ADDENDUM NO 1

TO: All Prospective Bidders
DATE: 8/17/17
PROJECT: New Residence Hall (WP-16-01-99-B)

Attachment #1 - Contractor Staging Plan

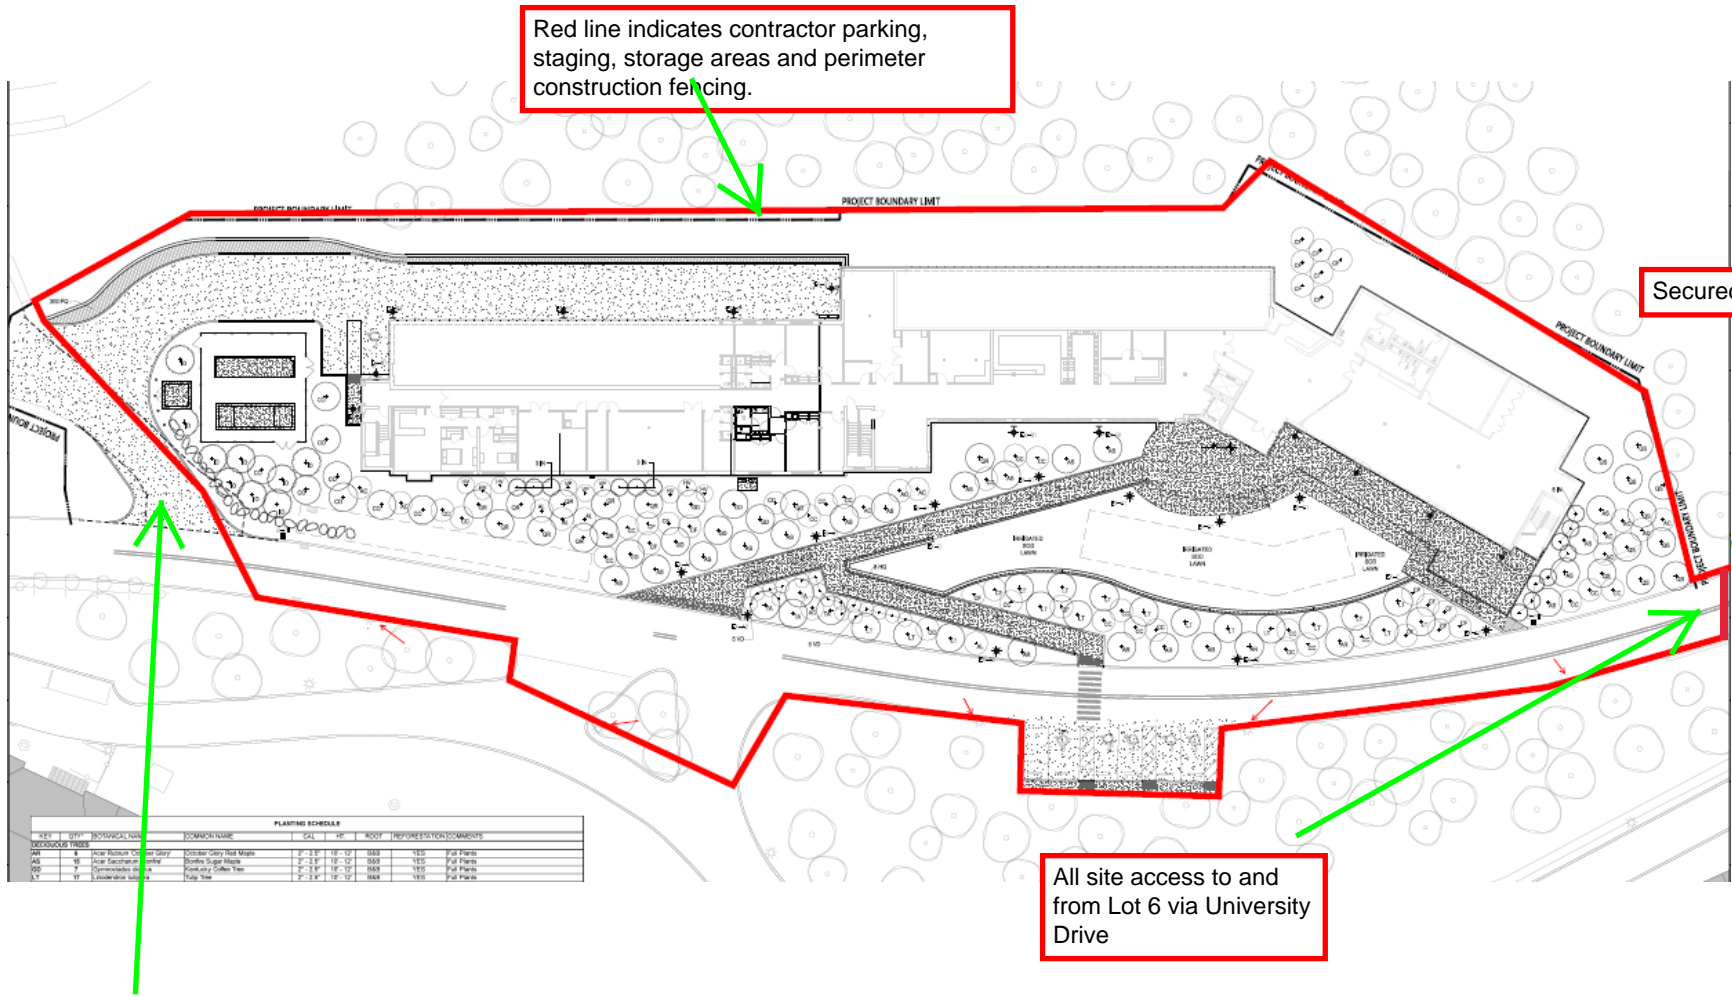
5. The contractor’s parking, staging and storage area is defined by Attachment #1. There is no other location on campus designated for contractor storage or staging for this project. Any work outside of this area must be scheduled with the University in advance. Parking is also available in Lot 6 on a first come first serve bases with no overnight parking. Please note that drawing CE-101 identifies the direction traffic will leave as “plan north”. The access to the site is the same, from “plan north”. The roadway identified for vehicle access leads to Lot 6, which can be accessed from University Drive. Contractor shall provide, install and maintain a continuous 6’ high construction fence surrounding the entire staging area with a securable gate at the access point with double padlock. Construction fencing facing other campus buildings shall be provided with a concealing green mesh. Construction fencing must be arranged in a manner to allow University access for garbage trucks and other service vehicles at the High Mountain service driveway.

1 ELECTRICAL SITE PLAN
SCALE: 1" = 20'-0"

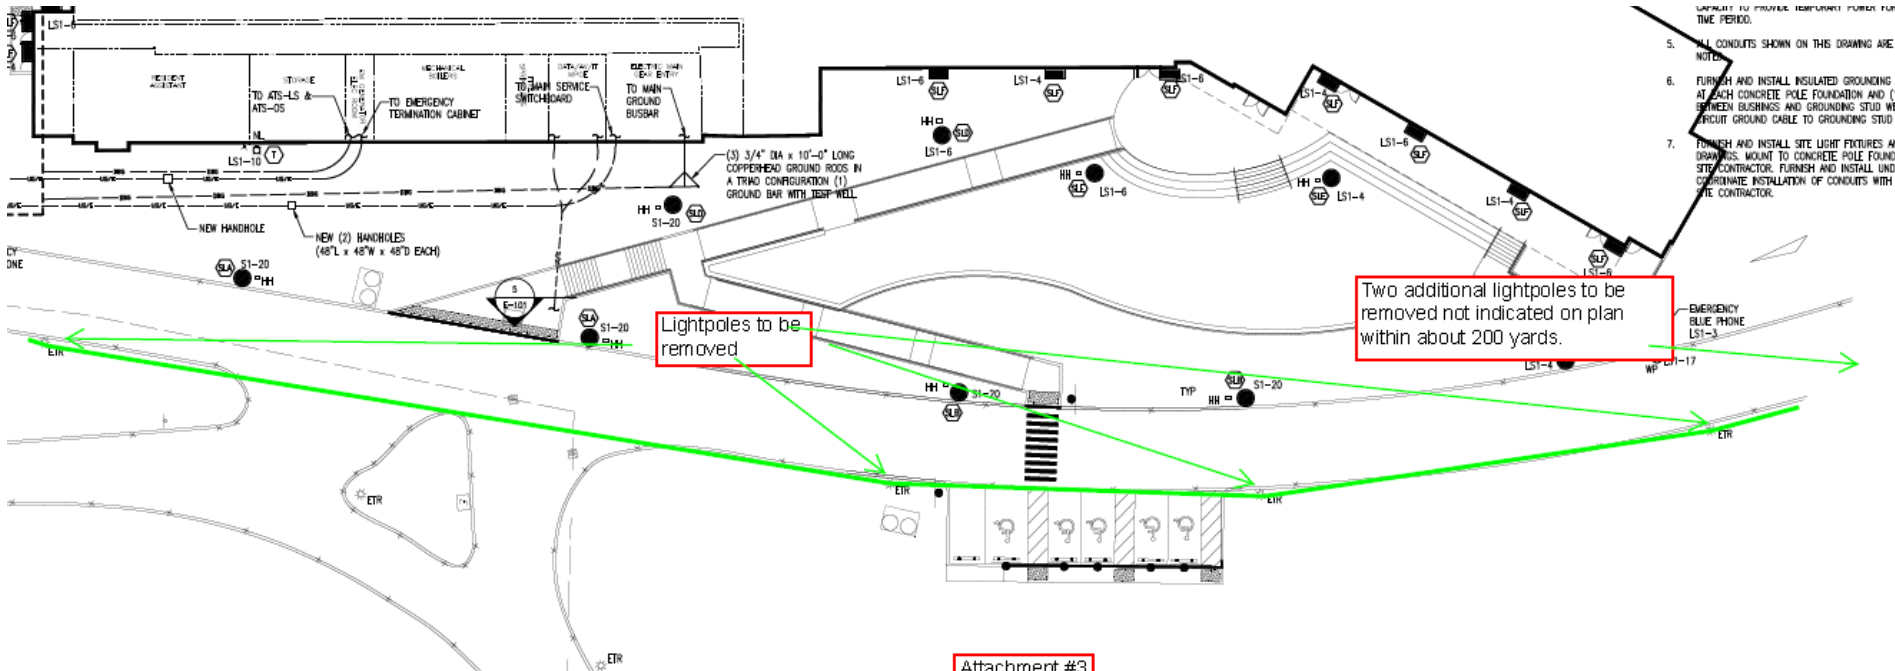
10. Drawing E-101, Detail 1 shows several light poles indicated as existing to remain (see Attachment #3). The underground electrical feed between the light poles has been indicated by an added line. This line serves exterior lighting for pedestrian and vehicle safety outside of the project site. As a result this underground feed must be protected, maintained, repaired and replaced by the contractor for the duration of the project. Once the new exterior lights for the new residence hall are operational and accepted by the University, the feed will be disconnected by the University and the contractor will be required to remove and dispose of 6 existing light poles and bases that are currently scheduled to remain in the drawings.
